ADDENDUM NO. 2  
TO  
Bid Documents  
FOR  
City of Sausalito  
Urgent Sewer Replacement Project

August 27, 2015

**DETAIL** B  
VAR

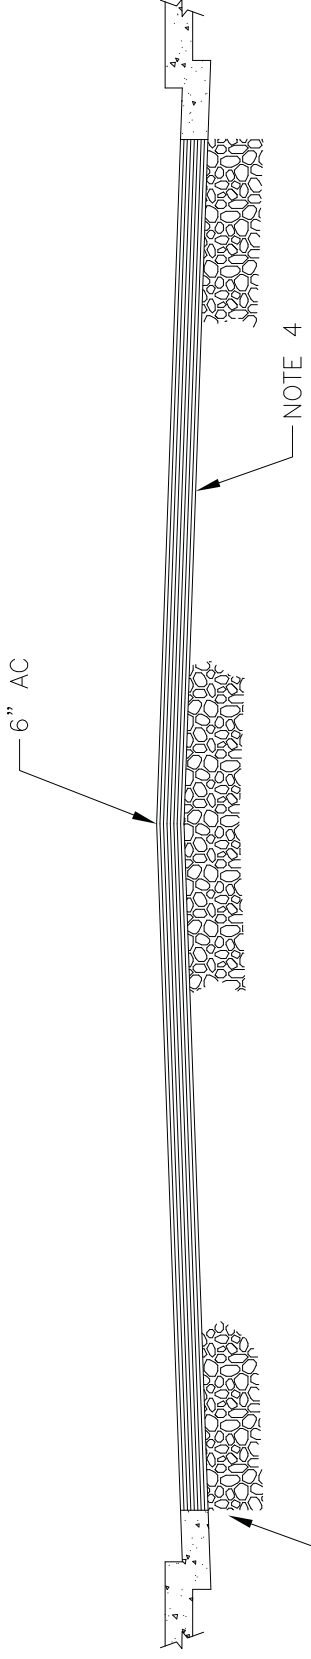
1. Replace Detail B with attached detail (1 page).

4" MIN AC, REFERENCE SPECIFICATION 02742  
 12" CL II AB, COMPACT TO 95% MAX DENSITY  
 MATCH EXISTING GRADES  
 VERTICAL SAW CUT FULL DEPTH AC, OR  
 CONCRETE PAVING. SEE NOTE 6.

1. AT THE DIRECTION OF THE CONSTRUCTION MANAGER, SURFACE IMPROVEMENTS UNDERMINED BY LOSS OF UNDERLYING MATERIAL SHALL BE REMOVED, THE VOID FILLED AND COMPACTED WITH APPROVED MATERIAL, AND THE SURFACE RESTORED TO PRECONSTRUCTION CONDITION.
2. COMPACT BACKFILL MATERIAL TO 90% RELATIVE COMPACTION. WITHIN 2' OF PAVEMENT SUBGRADE, A MINIMUM OF 95% RELATIVE COMPACTION IS REQUIRED.
3. NOT USED.
4. SEE SECTION 15076 FOR TRACER TAPE AND TRACER WIRE REQUIREMENTS.
5. LATERAL TRENCH NOT SHOWN BUT SHOULD BE REPAIRED SIMILAR TO MAIN TRENCH.
6. SEE POTHOLE KEY ON C08 FOR EXISTING ROAD MATERIAL AND APPROXIMATE DEPTH.
